**Meeting:** 3/19/2025  
**Applicant:** Josh Braden Braden Family Properties, LLC  
**Owner:** Josh Braden Braden Family Properties, LLC  
**District:** Oakwood/Lincoln Park Infill Housing Overlay District

**Location:** 212 E. Morelia Ave. **Parcel ID:** 81 F T 009  
**Zoning:** RN-2 (Single-Family Residential Neighborhood)  
**Description:**  
New primary structure

Level III New Primary Structure

**3-A-25-IH**

SITE PLAN

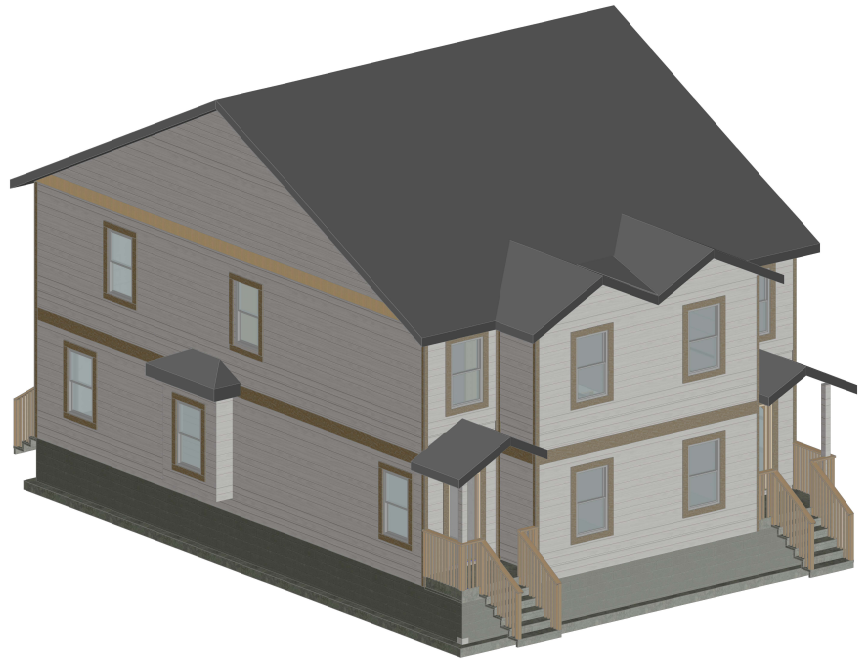
2. The house is proposed to be set 54.9' from the front property line. The average of the blockface is 18.4', with the adjacent houses at 20' and 22'. The house should be moved to be aligned with the front setback pattern of the block, to meet Infill guidelines and Middle Housing standards. The final site plan should include a walkway from the front porches to the street.

4. Parking is two adjacent 18' wide by 35' deep concrete pads and is accessed via the rear alley, which meets the design guidelines.
5. The 35'-4" wide duplex is compatible in façade width with original houses in the neighborhood and meets the maximum building width requirements in Article 4.6, Middle Housing standards, for a side-by-side duplex. The side elevations are large in scale but attempt to break up the massing with a bay window on each side and trim separating each story. The building is within the maximum depth for a side-by-side duplex in the Middle Housing Standards. Guidelines also recommend that multi-unit housing be similar in height to original houses on the street. The two-story building is taller than the surrounding context, as the block only features one and one-and-a-half story houses, except for the two-story, six unit apartment complex at the intersection with McMillan Street. The Board should discuss the height of the duplex. The duplex also features a 2' tall foundation, which increases the building's overall height.

10. Guidelines state that there should be a native or naturalized shade tree in the front and rear yards, and they also state that "Healthy trees that are outside the building footprint should be preserved. The root area should be marked and protected during construction." There was a mature oak tree in the back yard that was recently cut down. The remaining mature maple tree in the front yard should be retained and a new native or naturalized shade tree should be added to the rear yard. Both trees should be indicated on the revised site plan.

Staff recommends approval of Certificate 3-A-25-IH, subject to the following conditions: 1) final site plan to meet City Engineering standards, with major changes to the site plan to return to the DRB; 2) front setback to be revised to align with the front setback pattern of the blockface; 3) incorporation of additional design elements to meet Middle Housing standards, with minor revisions to be approved by staff; 4) the final site plan to include a walkway from the porches to the street; 5) the final site plan to include the existing mature tree in the front yard and a new native or naturalized shade tree in the rear yard; 6) revision to side elevation window placement; 7) the siding to be lap siding with an overlap instead of Dutch lap or flush panel; 8) meeting all relevant standards of Article 4.6. and Article 9.3.J.

Front Exterior Elevation  
Scale: 1/4" = 1'-0"

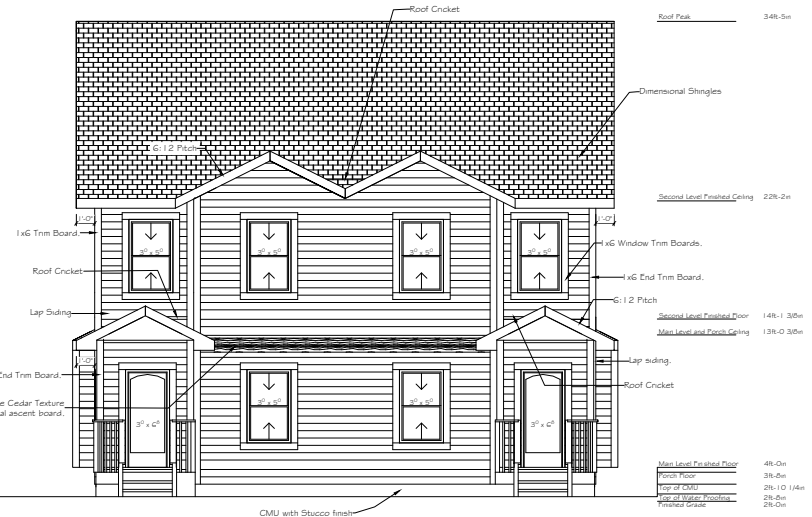
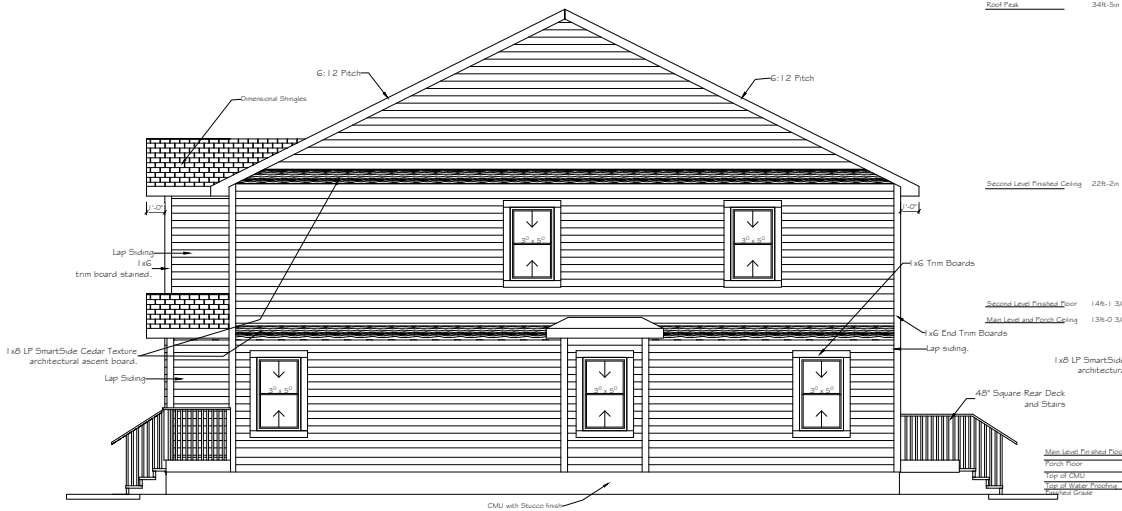
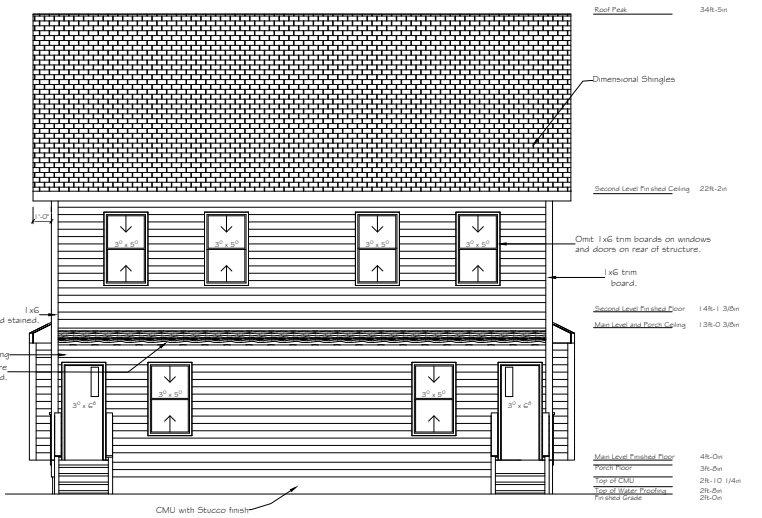
3. The guidelines for multi-unit housing recommend that "new multi-family buildings be designed in scale and context with the early architectural features of the neighborhood." The block to receive new construction is characterized by Craftsman bungalows, modified Queen Anne cottages, and infill construction. Almost all houses on the block are one or one-and-a-half story, except for a six-unit apartment complex at the intersection with McMillan St. The duplex is proportionate to the dimensions of the lot and to other houses on the block. It does not incorporate any details which align with the architectural context. Additional design elements are also required by the Middle Housing standards.

7. At least a 6/12 roof pitch is required in the Middle Housing standards to fill the "steep" category of roofline; 6/12 is also the minimum pitch approved by the Infill Housing guidelines. The large building may also benefit from additional variations in roofline, particularly on the larger side elevations.

8. Guidelines recommend window and door styles be similar to historic houses on the block, with similar placement and ratio of solid to void. While all four elevations feature sufficient transparency for the historic context, some revisions may be necessary to better align the buildings with the historic context (including the irregular placement of windows on the side elevations).

9. The elevation drawings feature horizontal siding (no materials provided) and a stucco-clad CMU foundation. The siding should feature a horizontal overlap similar to wood siding instead of Dutch lap or flush panes.
